Oyster Creek Nuclear Generating Station

Unresolved Problems With Drywell Corrosion

January 18, 2007

Richard Webster, Rutgers Environmental Law Clinic
on behalf of the Coalition to Stop the Relicensing of
Oyster Creek

The Sandia Study

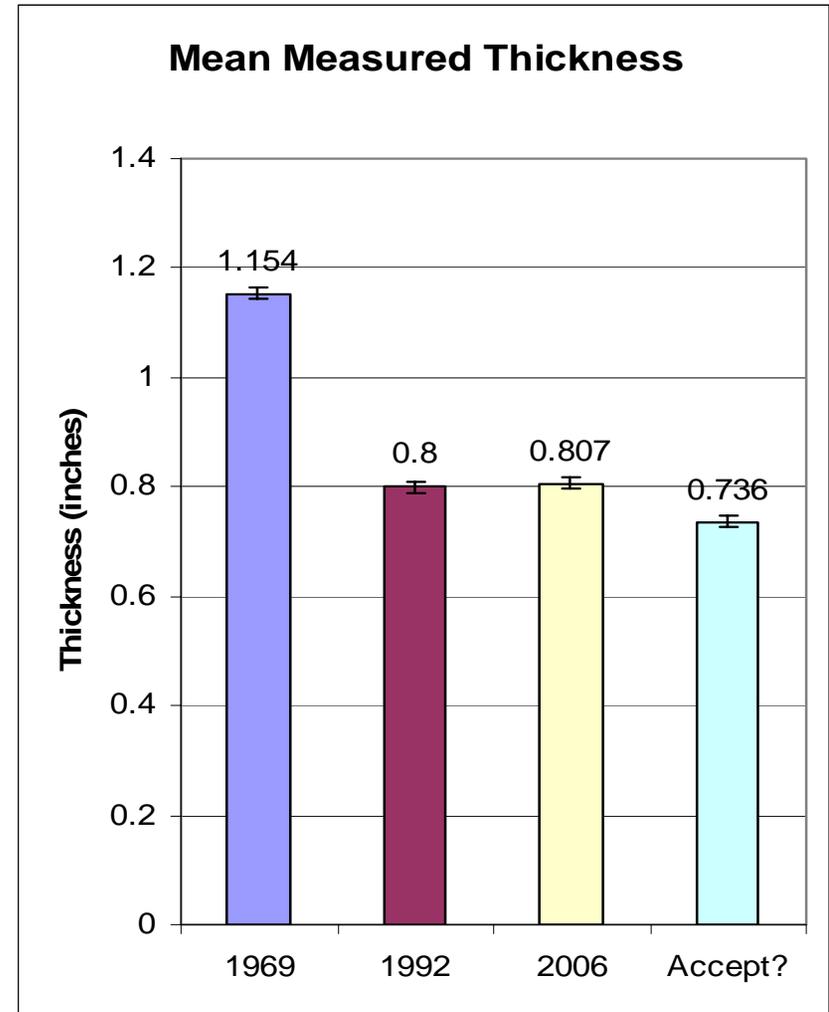
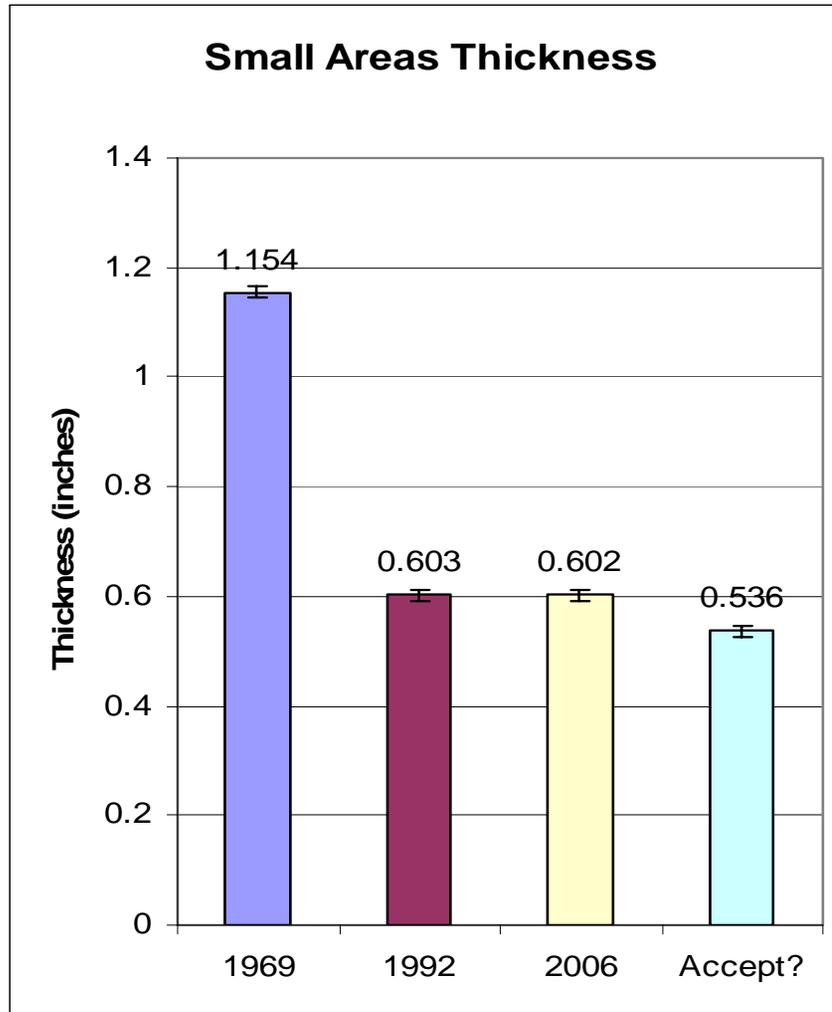
- Sandia model shows:
 - locally thin areas are significant and degradation has caused a 43% reduction in safety factor for the buckling in the sandbed under refueling conditions
 - GE model for buckling under refueling conditions was over optimistic, 0.844 inches uniform thickness needed, not 0.736 inches
 - Under accident conditions bending stress at the transition point at the bottom of the sand bed would be excessive
 - Safety factors for buckling under refueling conditions predicted at 1.95 in the upper drywell and 2.15 in sandbed
- Model fails to take account of measured thinning in the sandbed exterior measurements in October 2006
- Sandi failed to estimate the uncertainty of the prediction of the safety factor or its sensitivity and did not attempt to produce acceptance criteria for future corrosion

Extreme Value Statistics for 1992 Exterior UT Results in Bay 13

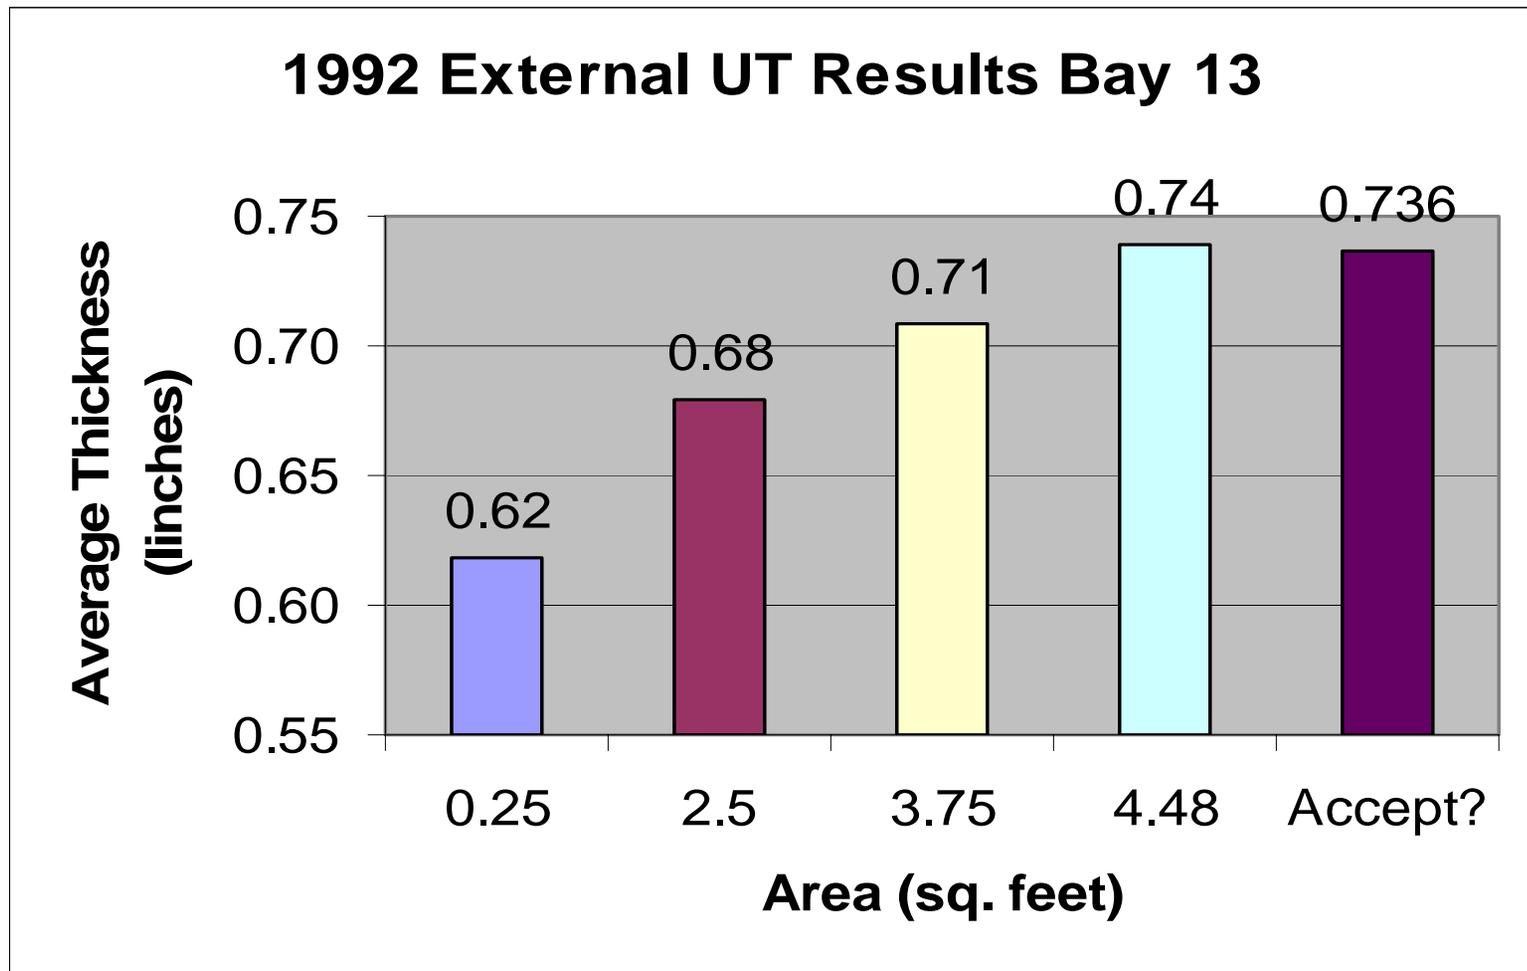
2.5% chance a single point measurement would give thickness less than 0.536"
 At 99% certainty shell thickness at each point is > 0.449 inches

Sensitivity of Area Below 0.736 Inches to Thinning

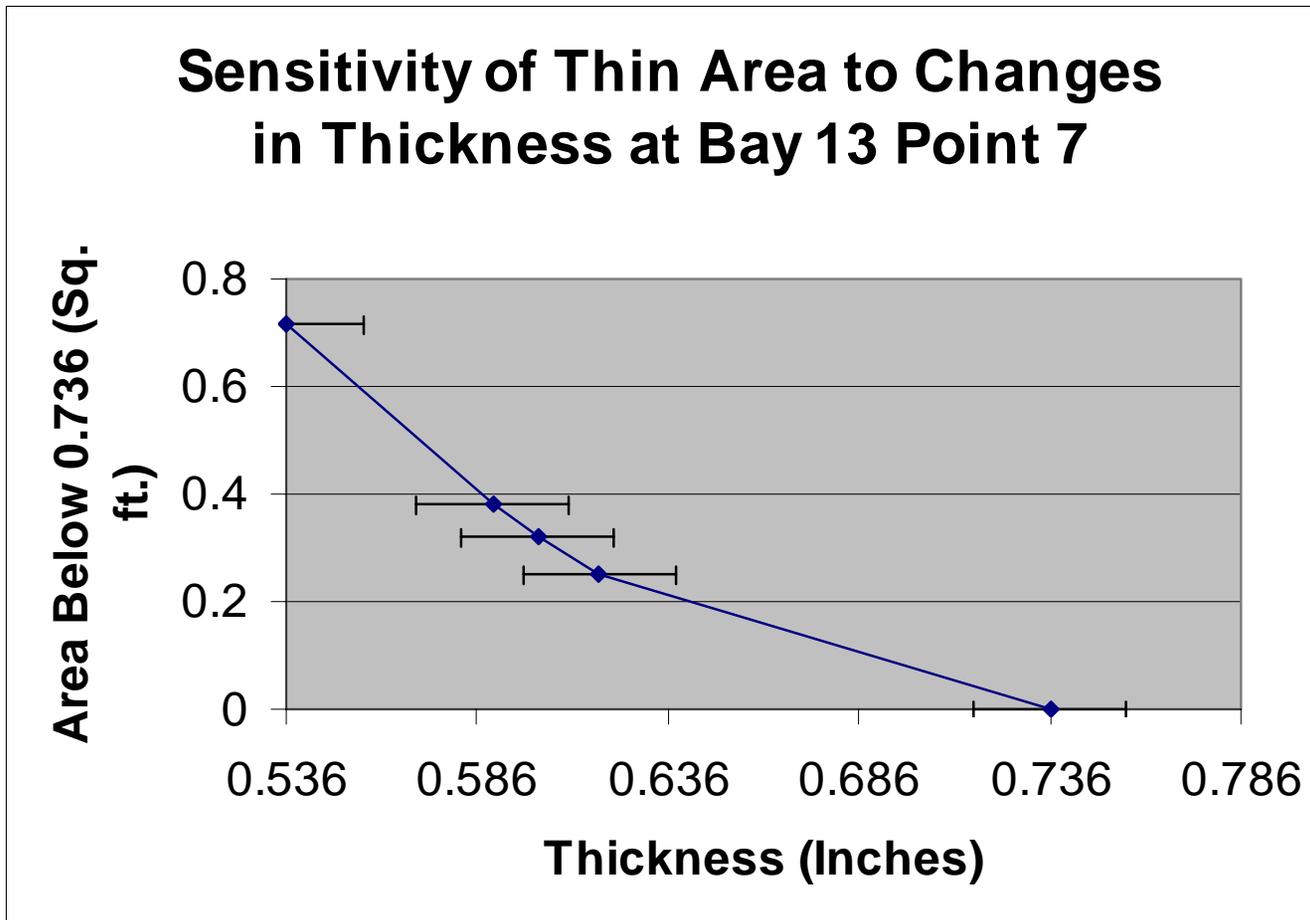
For illustration assume constant side slope and conical shape
Use known result that Point 7 in Bay 13 has min thickness of 0.618 inches and area below 0.736 inches of 0.25 sq. ft

2006 External UT Results

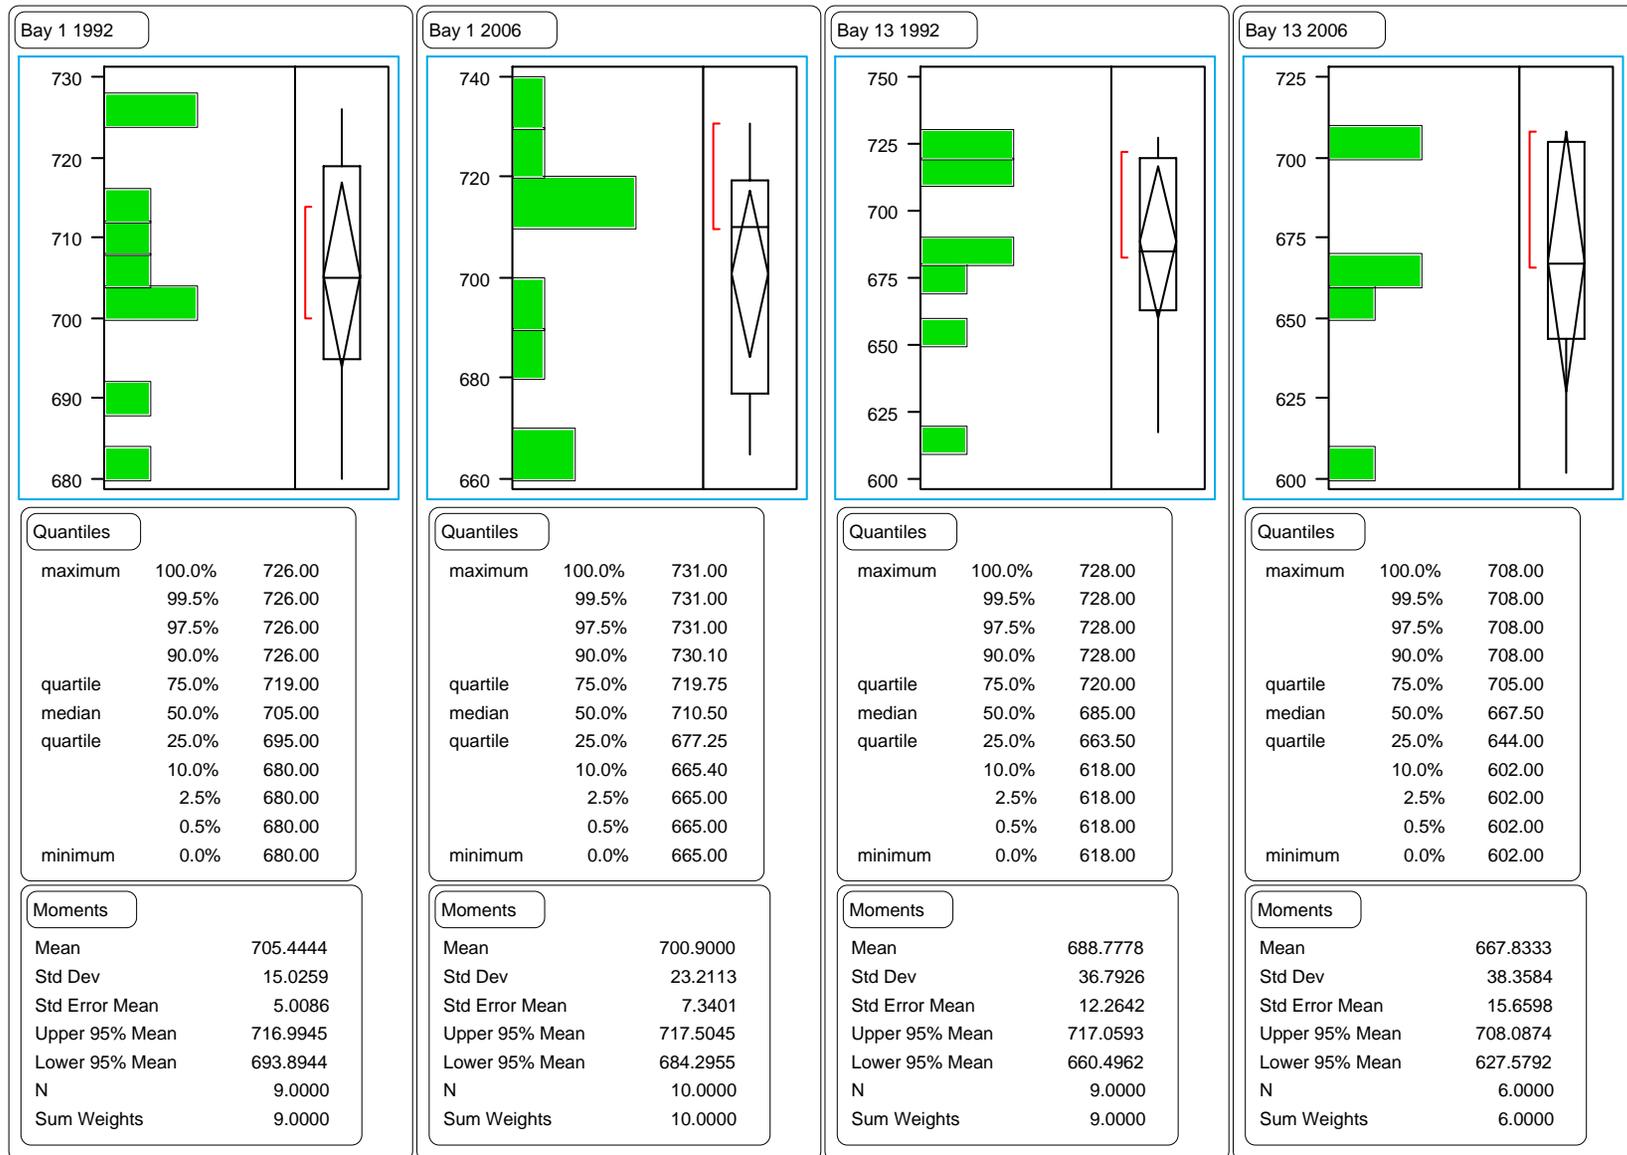
- Incomplete results presented in an opaque way in ACRS information package
- Thinnest point measured decreased from 0.618 inches to 0.602 inches
- Results indicated general thinning of the drywell shell by up to 0.039 inches
- Likely that shell is thinner than it was in 1992
- Even 0.02 inches of corrosion would be significant because claimed margin was 0.064 inches and thin areas expand quickly with additional thinning

Embedded Region

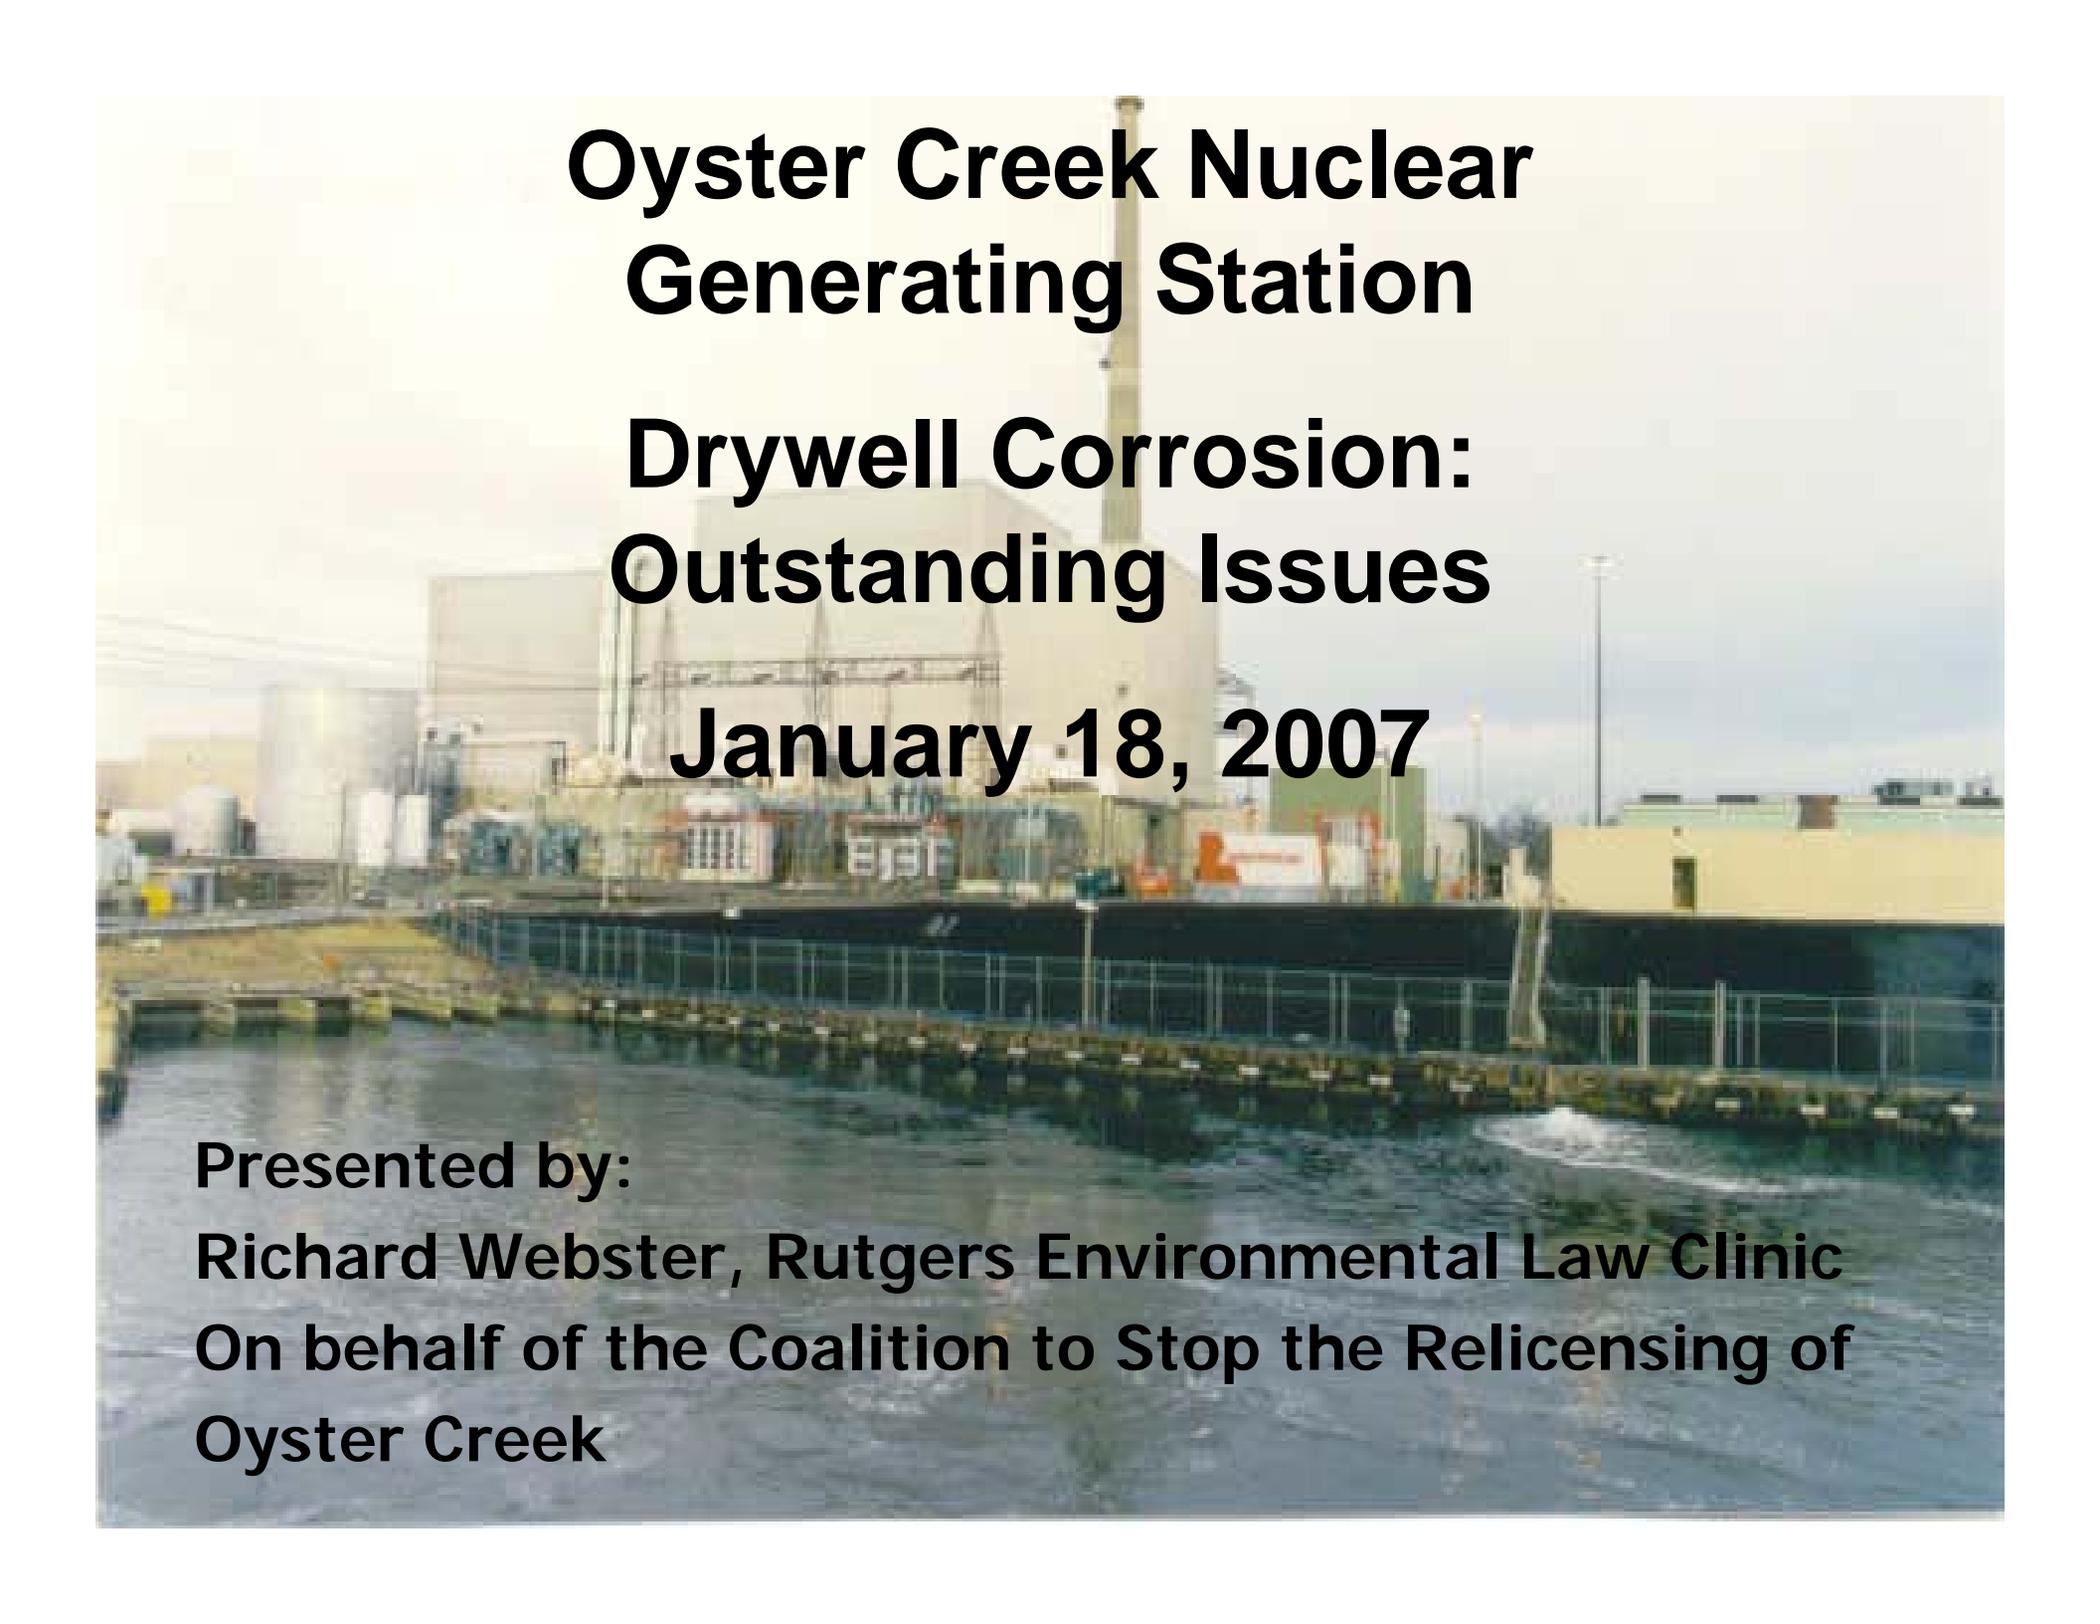
- Sandbed floor damaged when sand was removed
- Floor repaired with epoxy in 1992
- “Since 1996 inspections have found indications of epoxy separating from concrete” and “the separate seams could potentially allow some water to get under the epoxy coating repair” – AmerGen October 25, 2006
- Separation “could be caused by concrete swelling”
- Bottom of drywell is below the groundwater table
- Embedded region corrosion observed at Beaver Valley
- Drilled holes in interior concrete floor at Dresden to take UT measurements
- SER – could get a semi-quantitative assessment using guided wave technology
